Subject: Deny CDP #55-2006
Deny Special Condition No. 1 to CDP #1-83-270-A1

Ref: Drouillard letter dated October 19, 2007
Draft staff report released October 22, 2007

As an owner of property within the coastal zone near Gualala, and avid user of the Gualala Bluff Trail, the Gualala River and the Gualala Point Regional Park, I ask that you consider my comments regarding the staff report on the application for CDP #55-2006.

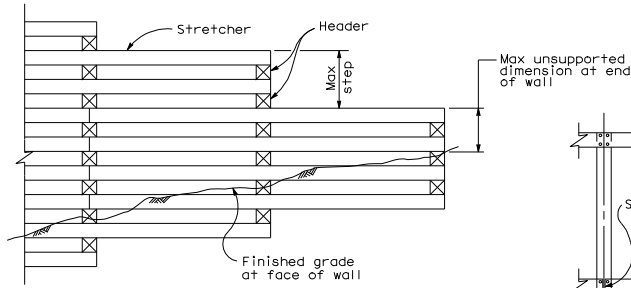
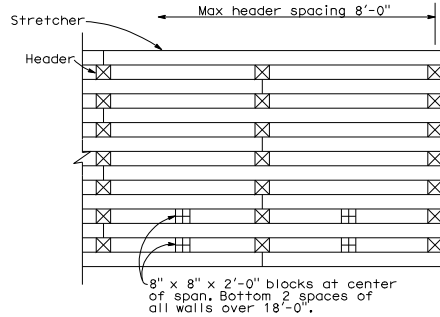
The visual impact of the proposed retaining wall is significant. Not only will it eliminate a substantial portion of unique bluff environment associated the Gualala River estuary, it will ruin Gualala's appearance as a town on a bluff above the river. (See attached sketch.)

The visual impact of the wall will significantly degrade the appearance of Gualala as the town on a bluff above the river.

TIMBER CRIB WALL TYPES A, B, C AND D

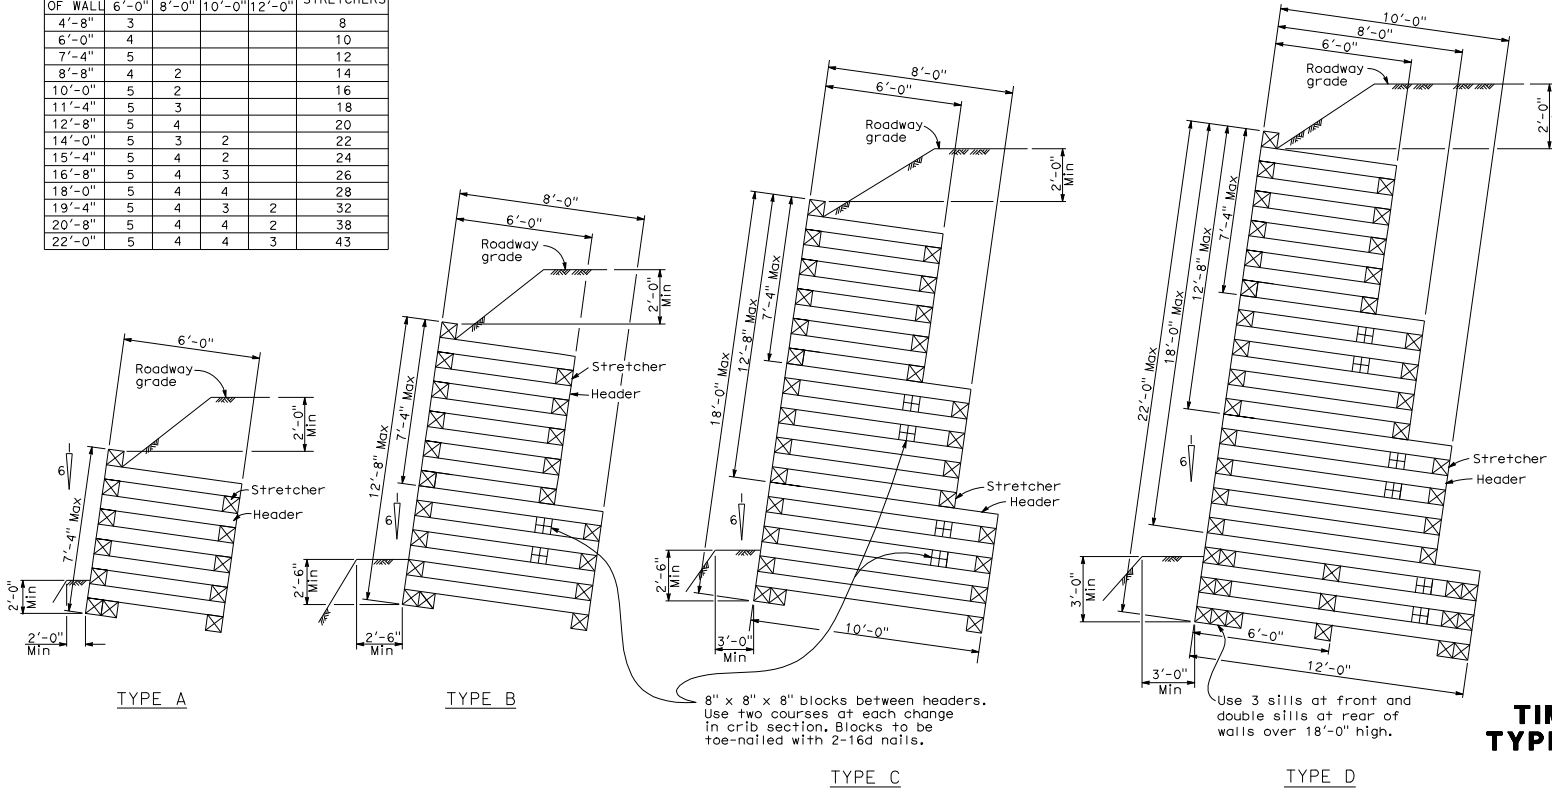
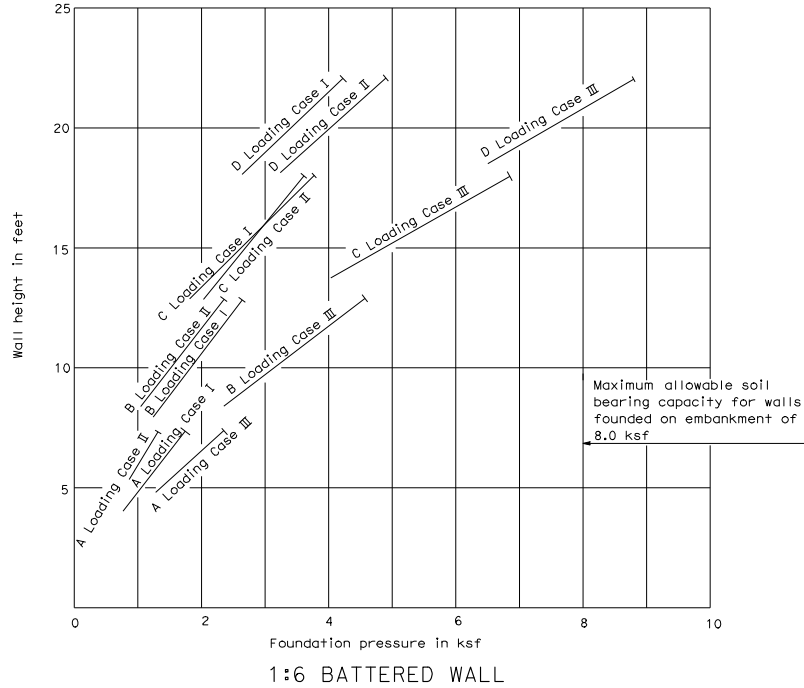
As described in my October 19, 2007 letter, constructing a timber crib wall aligned with the previous bluff edge is feasible at the location of the large debris slide behind Surf Super. The "Caltrans Timber Crib Wall Type D" can retain heights up to 22 feet with a 12-foot deep footprint. (See attached Caltrans standard plan sheets.) A timber crib wall will protect the existing development, restore the bluff trail and conform to Special Condition No. 1 without any amendments.

At the Surf Super parcel, a timber crib wall aligned along the previous bluff edge is a feasible alternative to the proposed concrete block wall. Such a wall could be built under Special Condition No. 1 as currently written.
